To: DRB, SB, UJFD, UCC
From: Sarah McShane, PZA
Date: 3/2/2015
Re: Agenda and Information for 3-2-2015 Hearing

**Final Subdivision Hearing on the Application of
Arnold Baizley for 2 Lot Subdivision**

Property Location: 623 Pleasant Valley Road (PV623)

Overall Site Plan

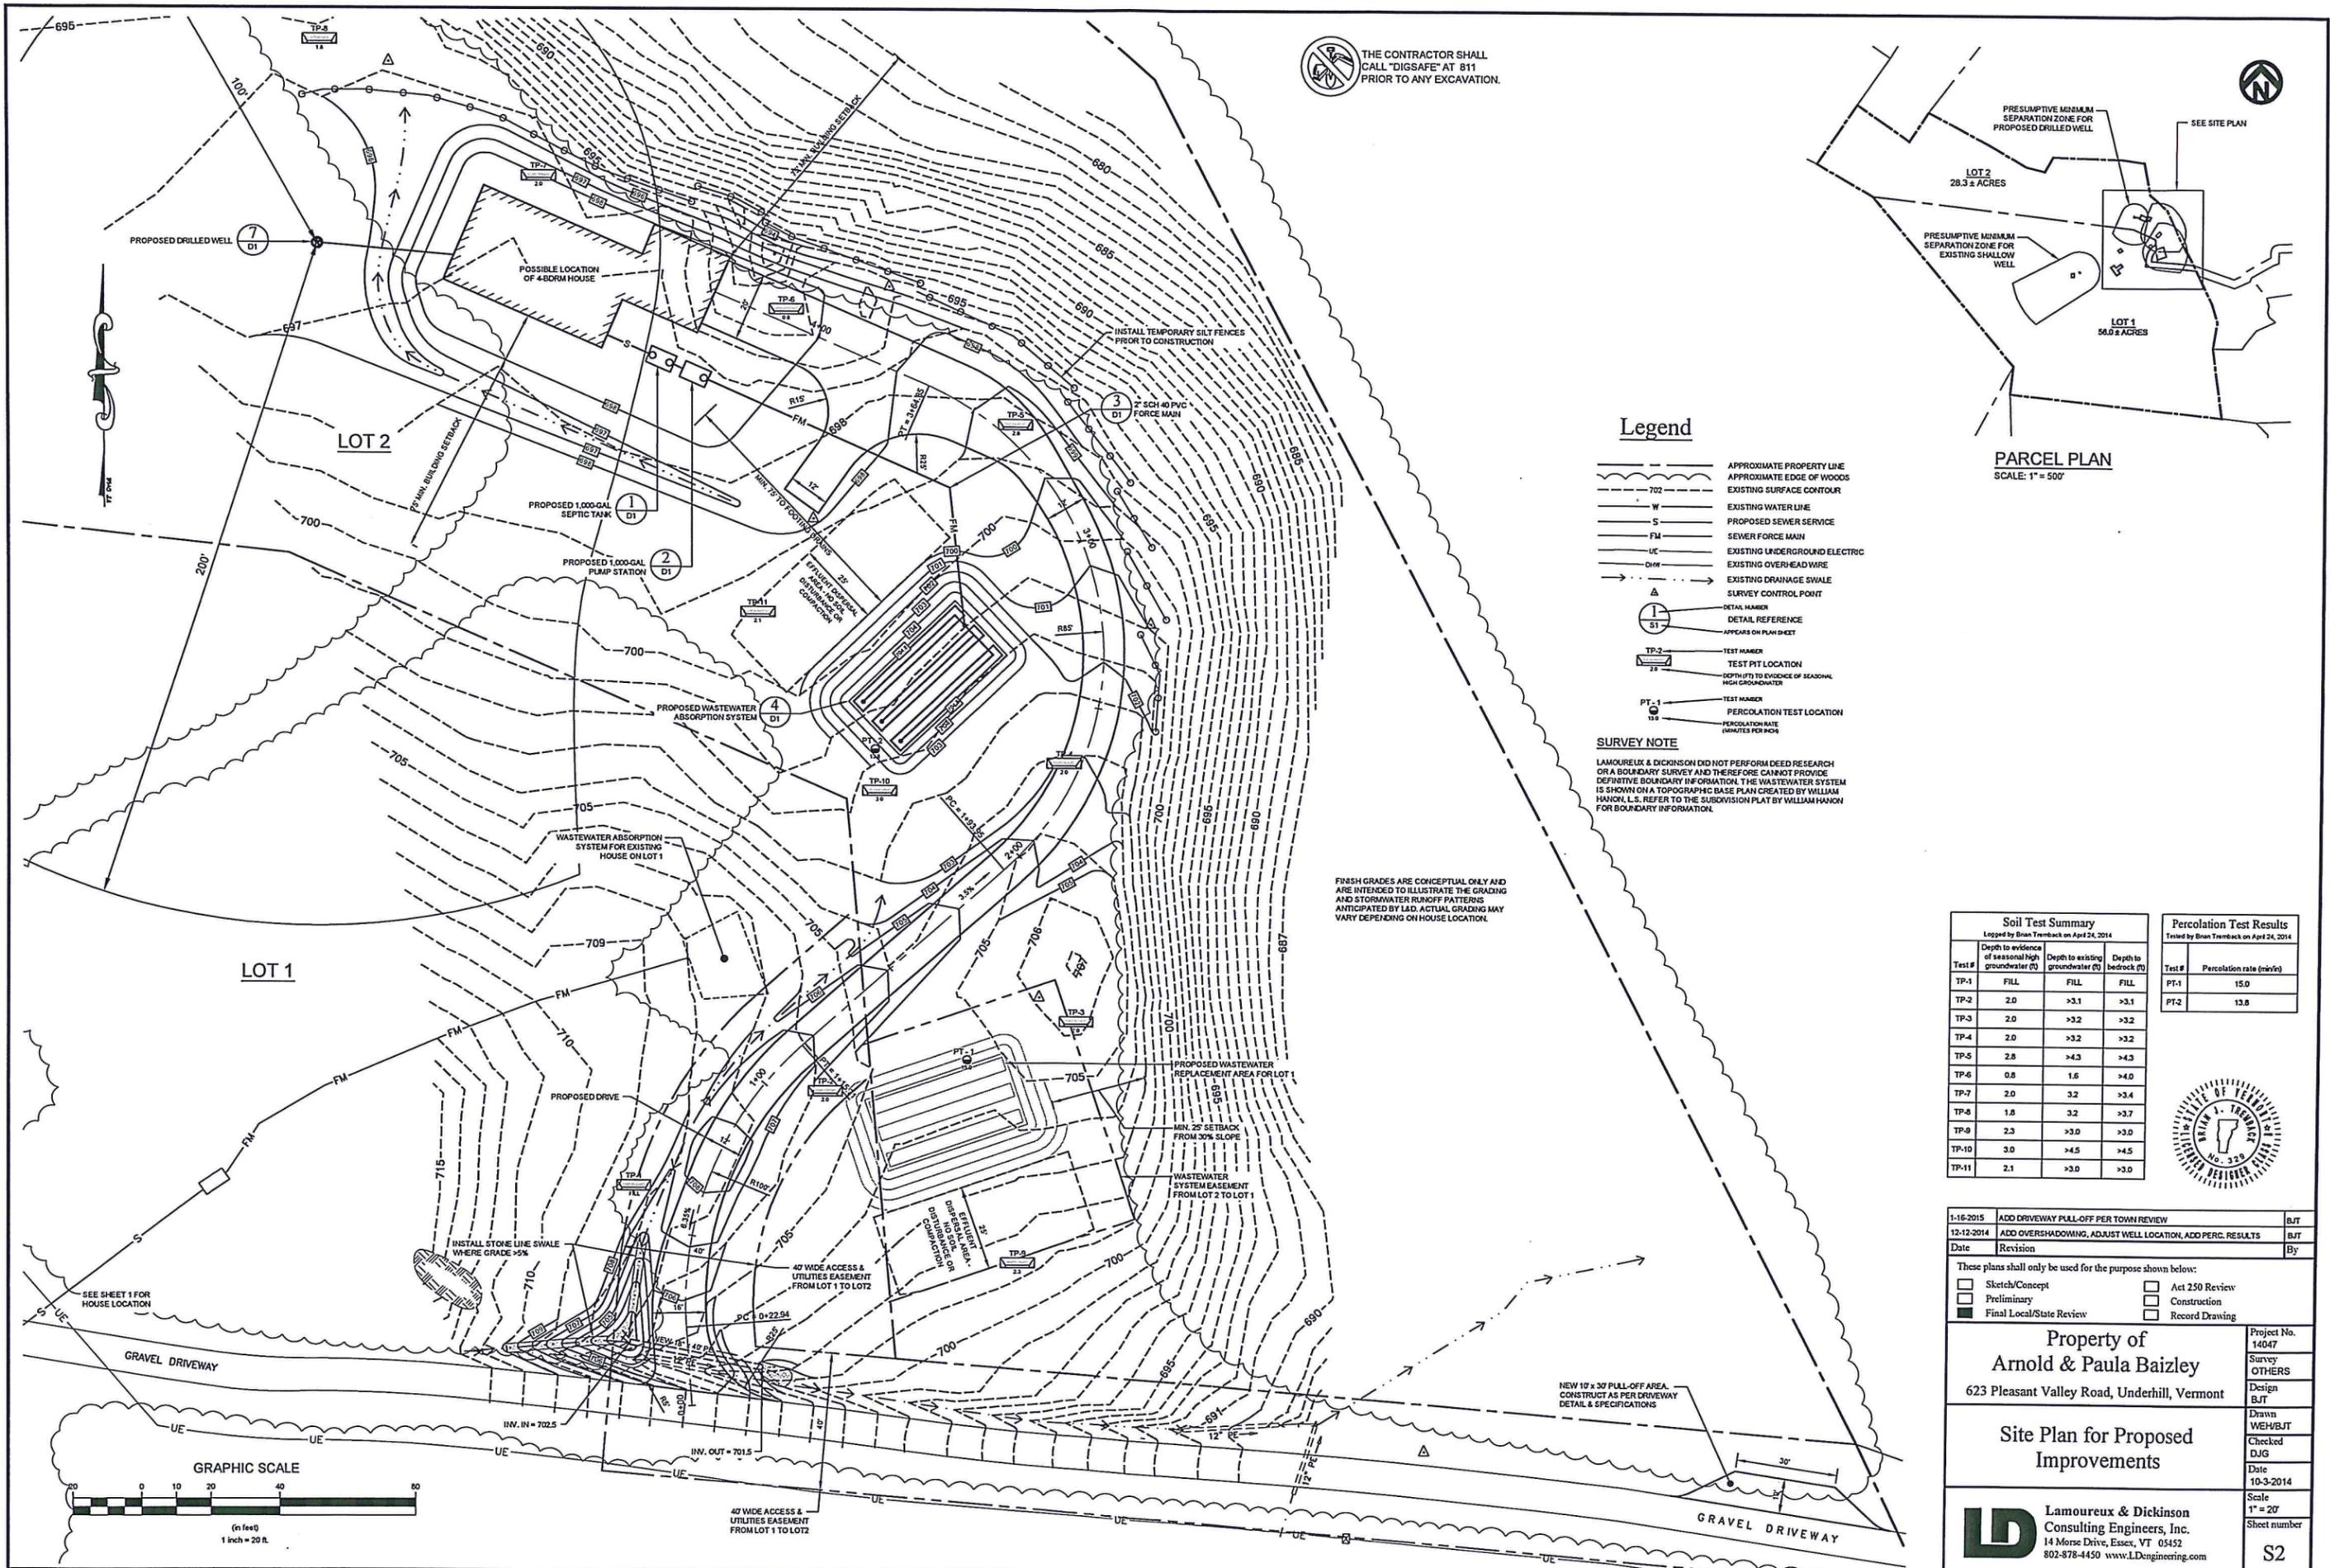
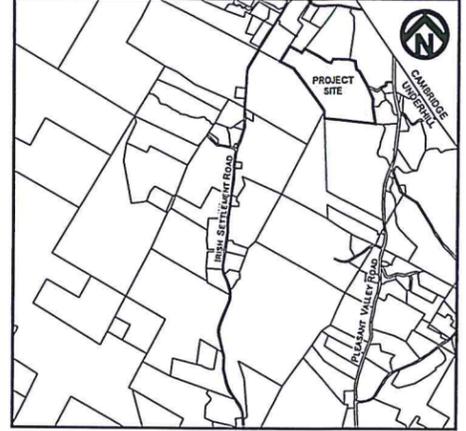
Only one principal structure is proposed per lot [Section 3.7(A)]. The subdivision appears to meet the requirements of Section 3.7(B). However, the setbacks indicated on the plans are measured from the proposed dwelling since a building envelope has not been designated.

A building envelope has not been designated on the plans. Section 8.2.G (pg 146) requires the designation of building envelopes to “limit the location of structures, parking areas, and associate site improvements.”

Site Plan for Proposed Improvements

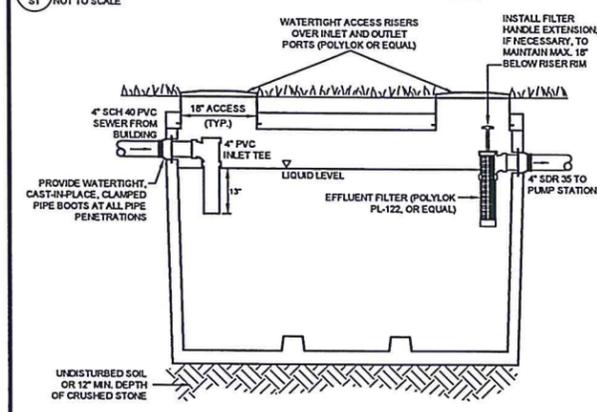
The Final Subdivision plans include the required 10' x 30' pull-off area (outside the mapped floodplain) as requested during preliminary review and during Access review by the Selectboard.

1-16-2015	ADD DRIVEWAY PULL-OFF PER TOWN REVIEW	BJT
12-12-2014	ADD OVERSHADOWING, ADJUST WELL LOCATION, ADD PERC. RESULTS	BJT
Date	Revision	By
